## Addendum Write Up

Addendum: 04

Project: 14049 Dexter Township, Michigan New Fire Sub-Station No 2

Addendum Reason: Response to Bidders questions

Sheet Number: A-301

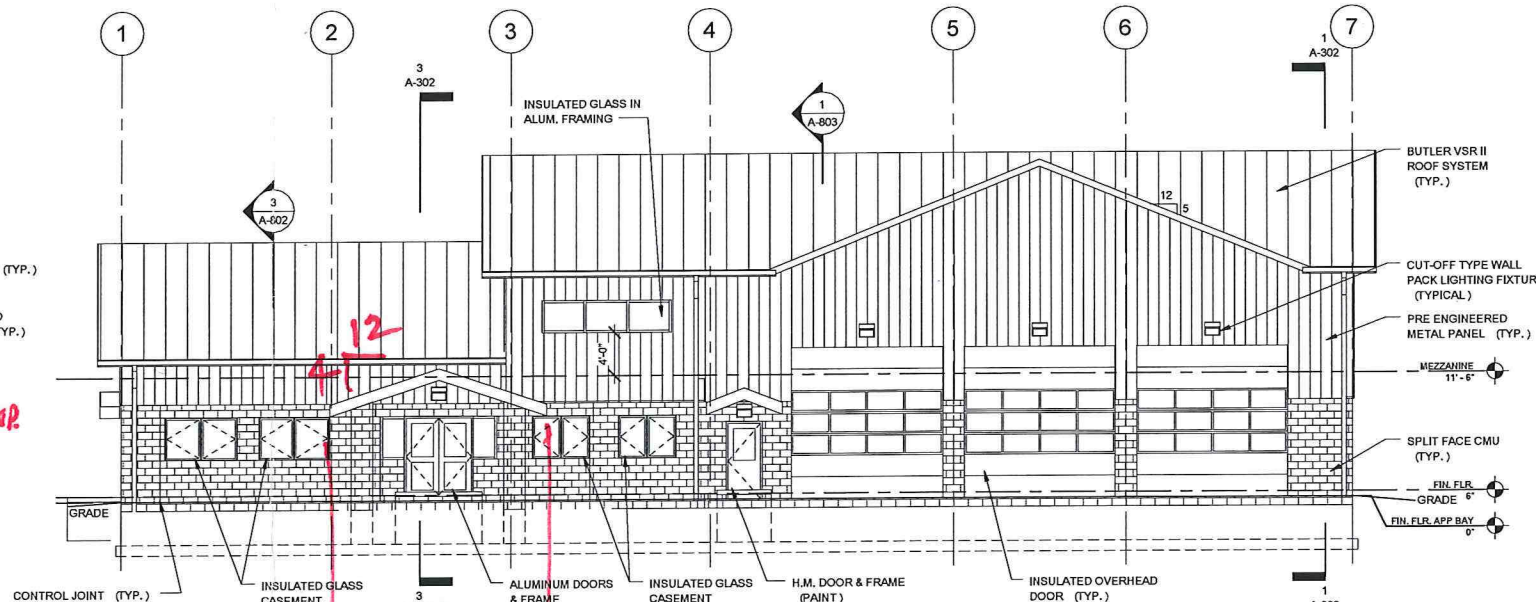
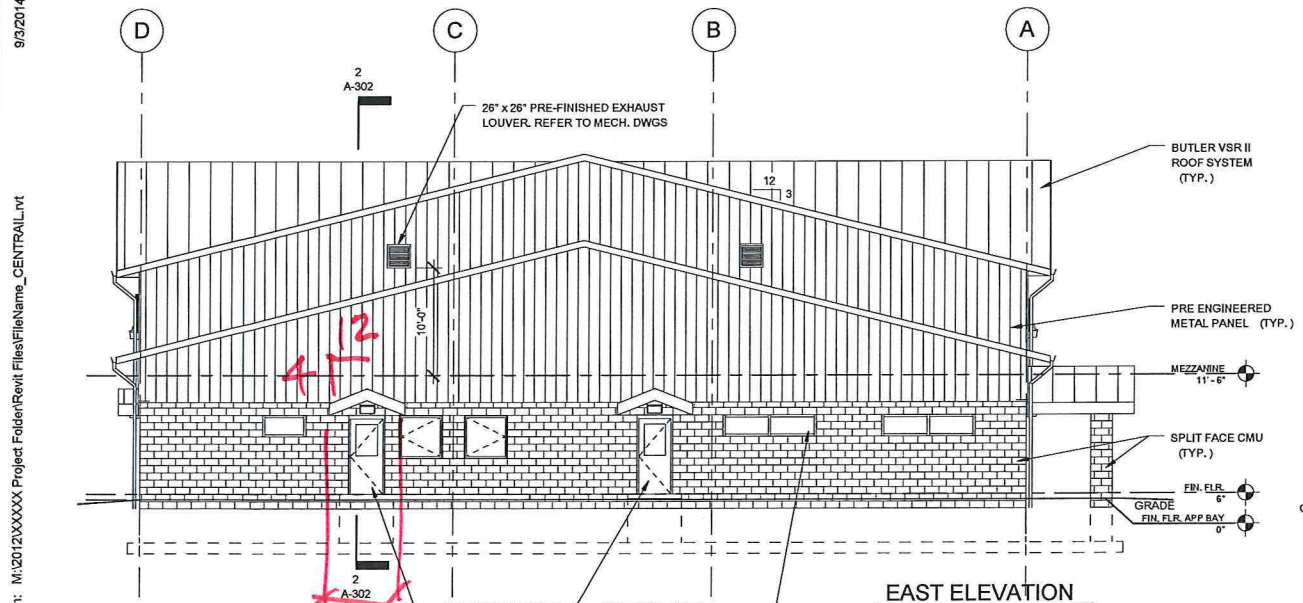
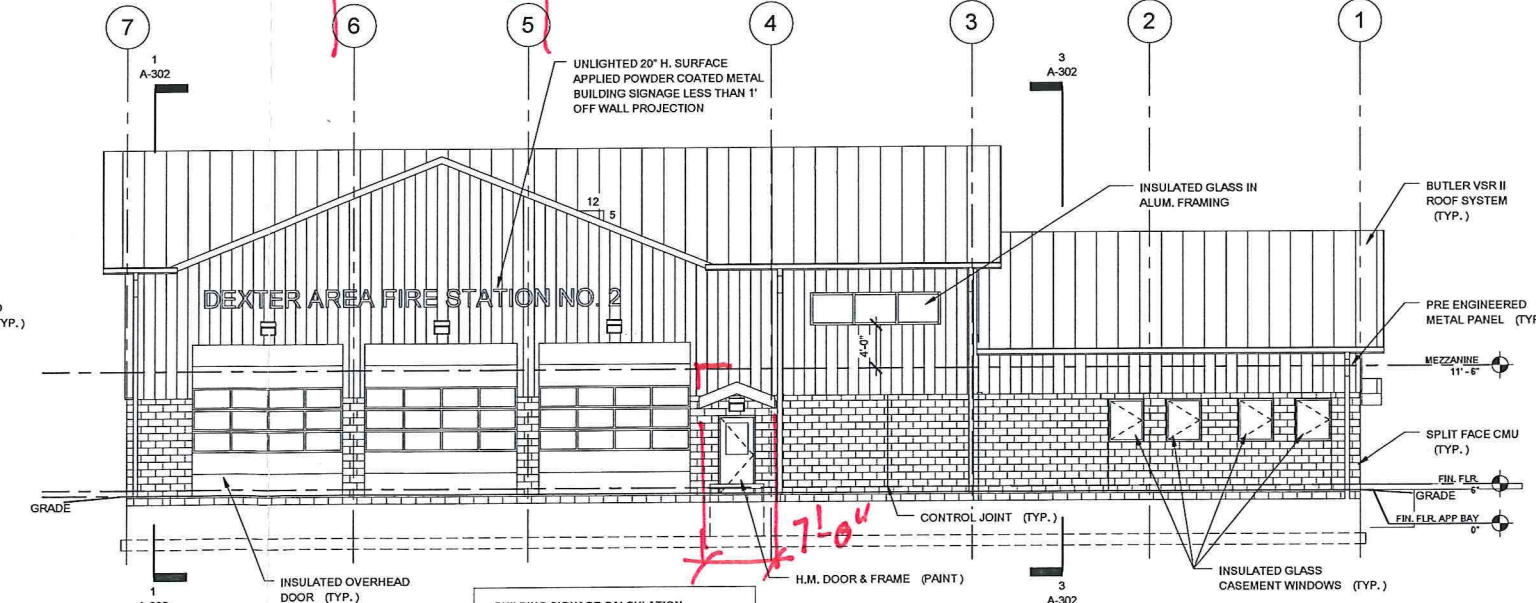
**Kitchen counters and toilet vanities to be Corian "Private Collection", price group "D". Color by Architect.**
10. Chain link storage shown on mezzanine. Is there a spec for this material (post, rail, mesh diameters, gauges, thickness of galvanizing, etc)

**Refer to attached wire mesh partition specification section.**
11. Specifications for lettering on front elevation of building? Font, thickness, manufacturer, steel or aluminum, etc....?

Sheet Number: **P-200**

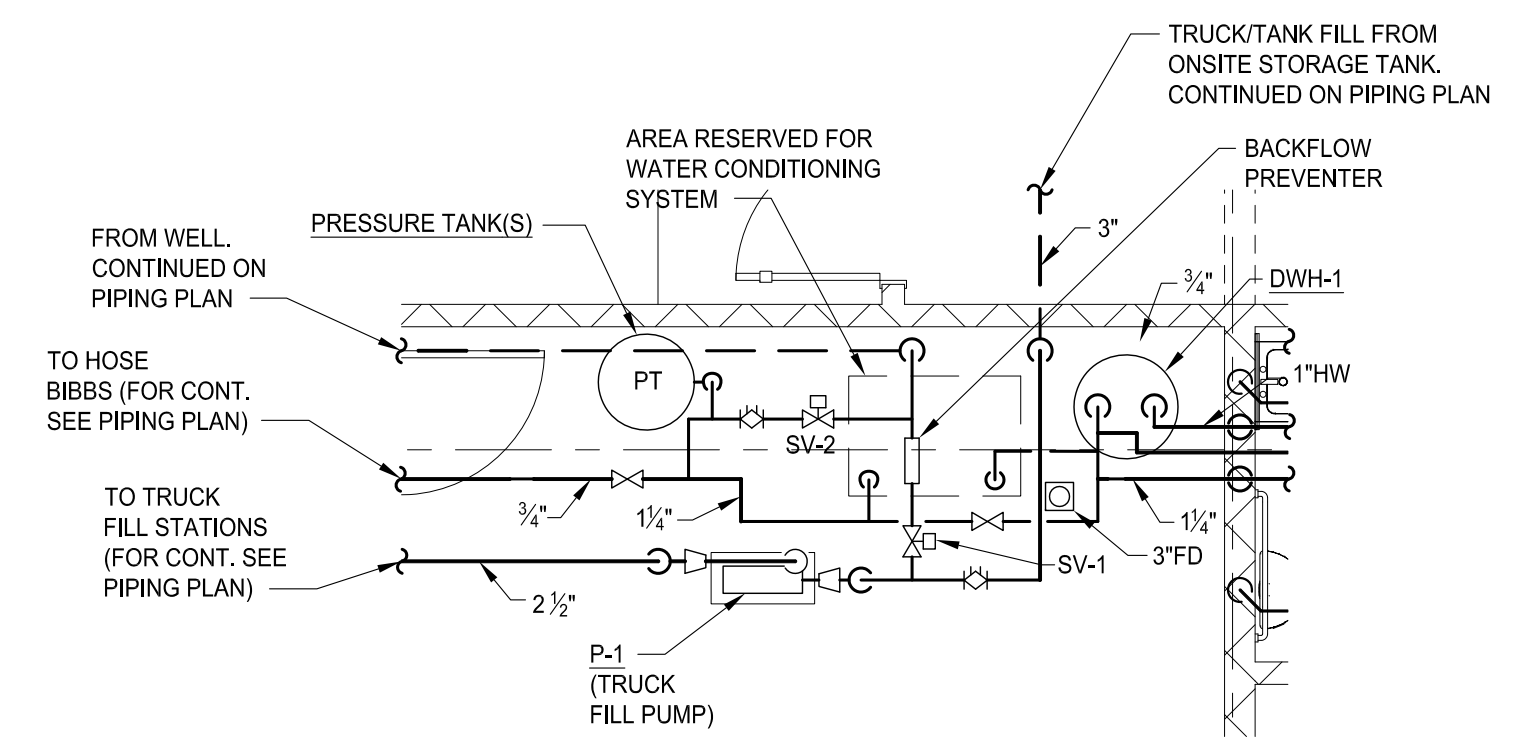
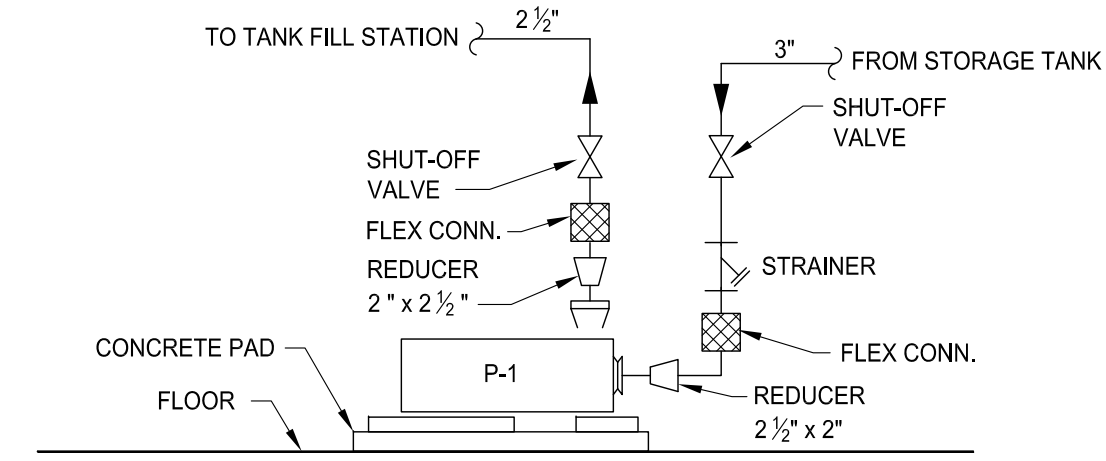
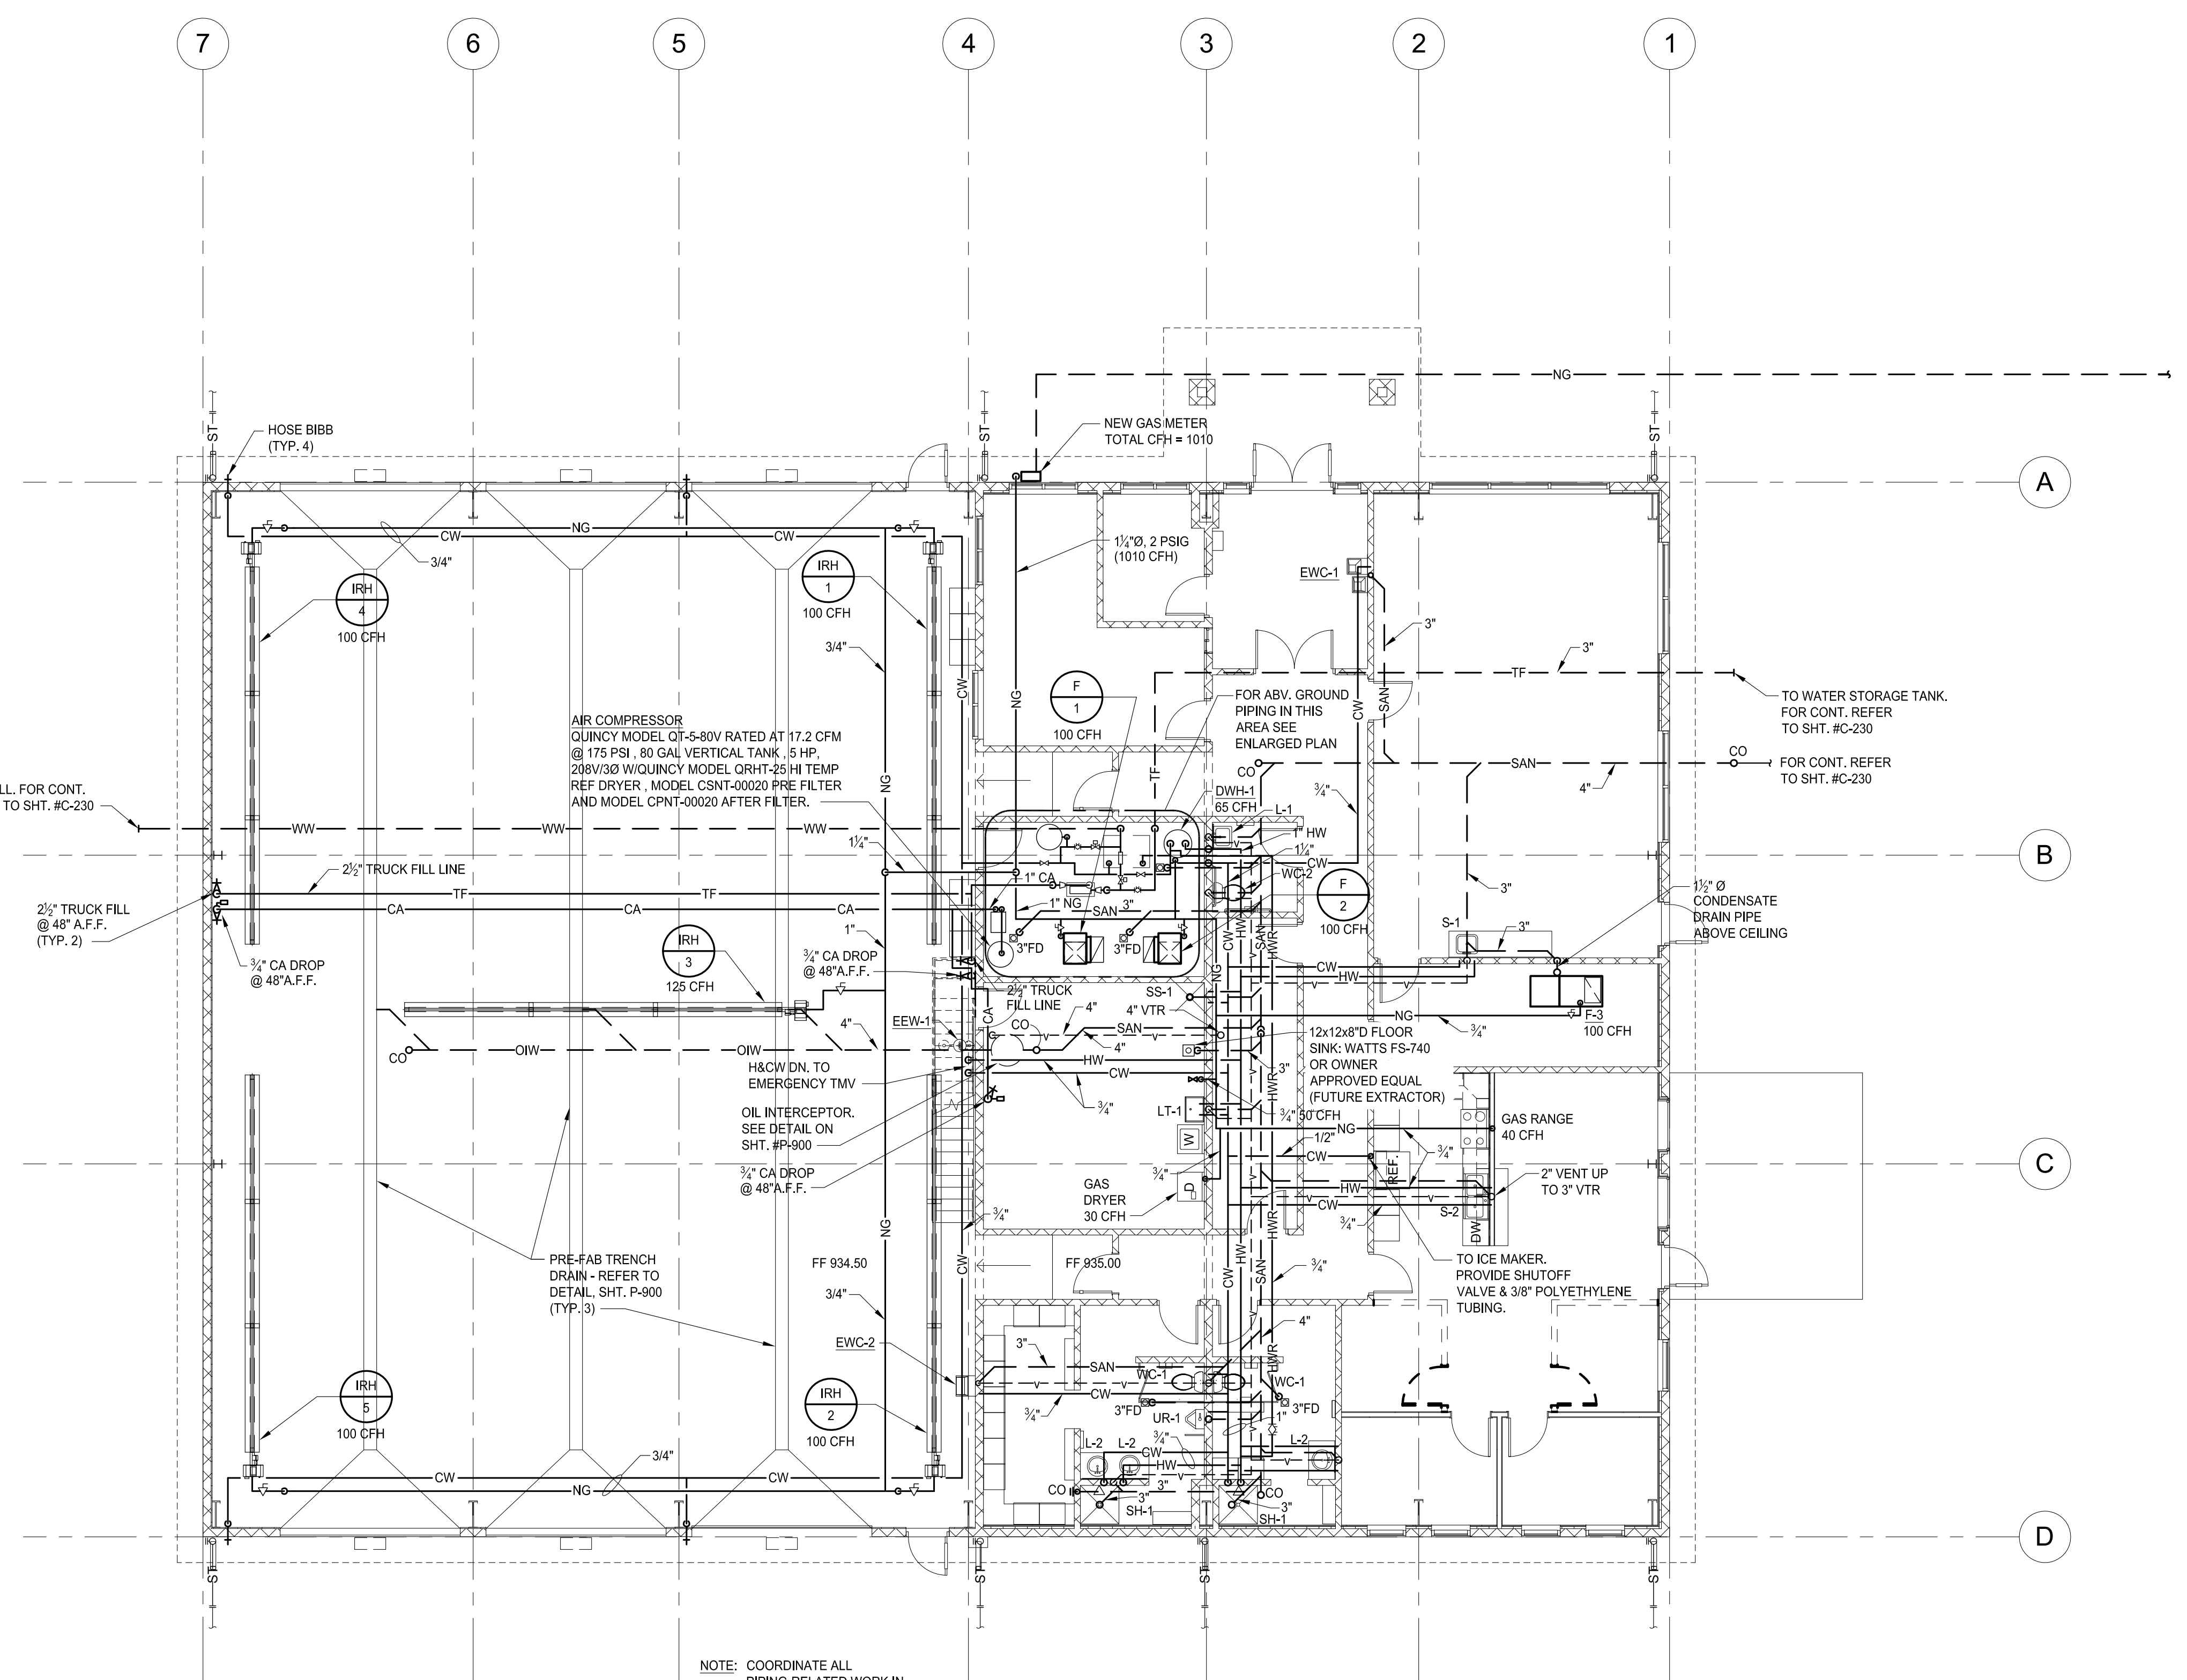
29. The detail for Domestic Water Heater DWH-1 Piping Diagram on P-900 shows a circulating pump (P-1) on a Hot Water Return pipe. The piping on P-200 does not show any hot water return pipe. Michigan Plumbing Code requires a recirculation pipe for any fixture that is beyond 50' from the hot water source. According to the scale, the furthest fixture is roughly 50' away. Are we to install the piping per P-200 or should the recirculation line be installed.

**Install recirculation line per attached revised drawing P-200.  
Note revision to Domestic Water Heater DWH-1 Piping Diagram indentifying recirc pump as P-2 and including Make & Model number. Note also clarification of trench drain grating in detail on sheet P-900.**
